Previous s.16 Applications covering the Application Site

Temporary Public Vehicle Park (Private Cars and Light Goods Vehicles)
for a Period of 3 Years
(A/YL-LFS/501)

A/YL-LFS/501 DD 129 Lau Fau Shan GB
29/12/2023 02:47

Site Plan

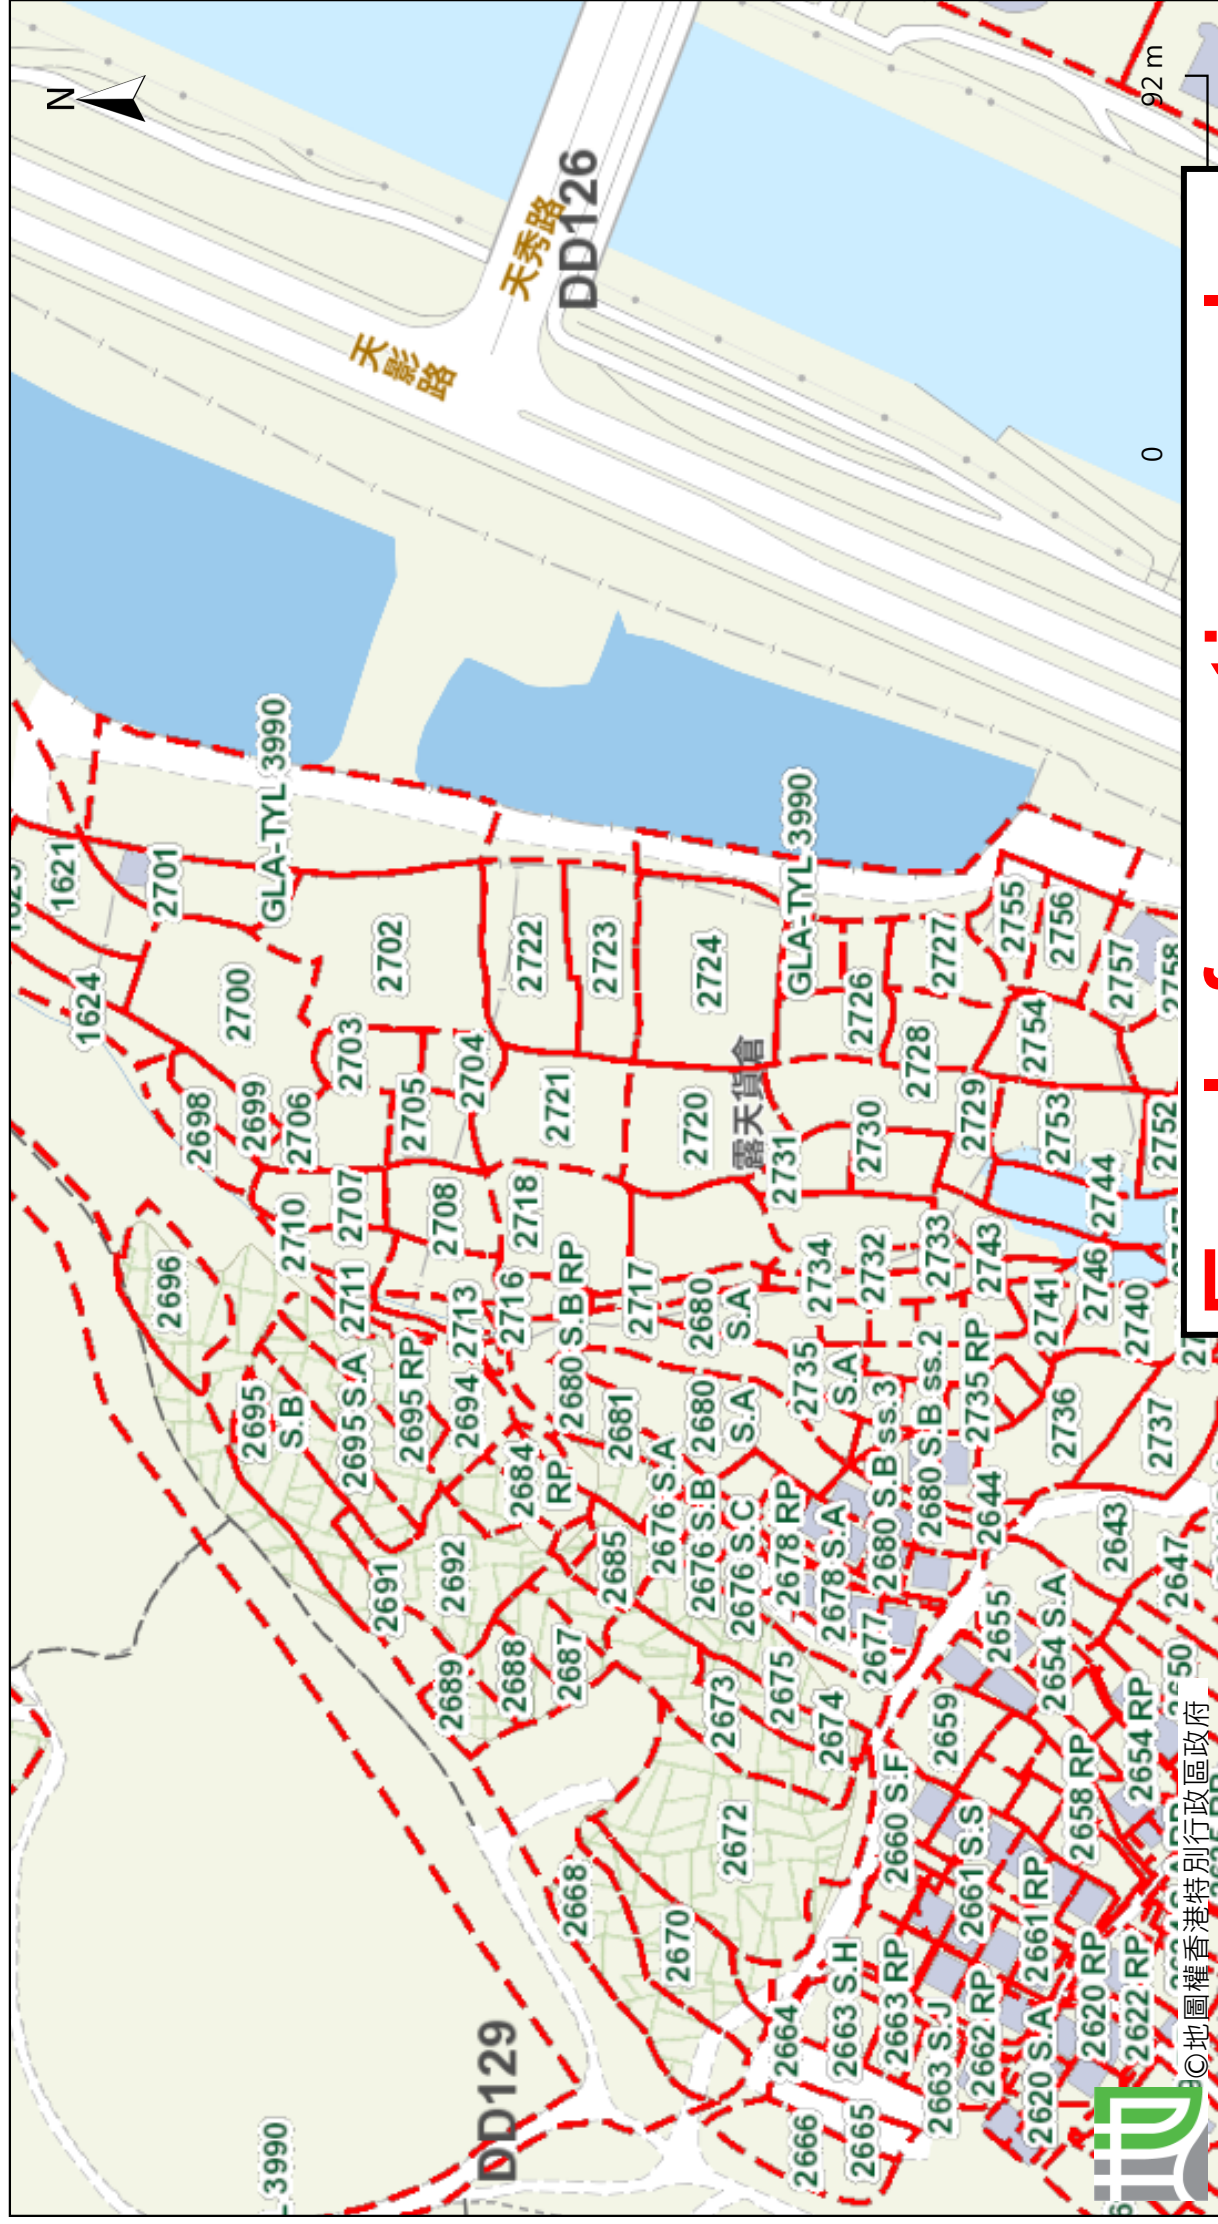
- (i) the ground to the west of the Site is generally higher. Since the overland flow from the adjacent lands shall be properly intercepted, external catchment to the west of the Site (other than the 2700m² catchment to the east of the Site, i.e. EC1) shall be considered in the calculation;

- (ii) please indicate clearly the full alignment of the discharge path from the Site all the way down to the ultimate discharge point (e.g. a well-established stream course/public drainage system);

- (iii) the existing village drain, to which the applicant proposed to discharge the stormwater from the Site was not maintained by DSD. The applicant should identify the owner of the existing drainage facilities and obtain consent from the owner prior to commencement of the proposed works. In the case that it is a local village drains, District Officer/Yuen Long should be consulted;

- (iv) further to (iii) above, since there is no record of the said village drains, please provide site photos to demonstrate with hydraulic calculation that the existing village drain (underground pipe) is adequate to collect, convey and discharge the surface runoff accrued on the Site and overland flow intercepted from the adjacent lands;

- (v) further to (iii) above, it is given to understand that there is no existing river at the downstream of the proposed discharge path which was indicated in the drainage plan. Please provide site photos to demonstrate its presence and existing condition;

- (vi) it is noted that there is no proposed drainage system to be constructed within the Site but only rely on the existing U-channel outside the Site. Please revisit. Peripheral surface channels shall be provided along the site boundary to collect the surface runoff accrued on the Site and to intercept the overland flow from the adjacent lands;

- (vii) where walls and hoarding are erected along the site boundary, adequate opening should be provided to intercept the existing overland flow passing through the Site;

- (viii) cross sections showing the existing and proposed ground levels of the Site with respect to the adjacent areas should be given;
 - (ix) the development should neither obstruct overland flow nor adversely affect existing natural streams, village drains, ditches and the adjacent areas, etc.; and
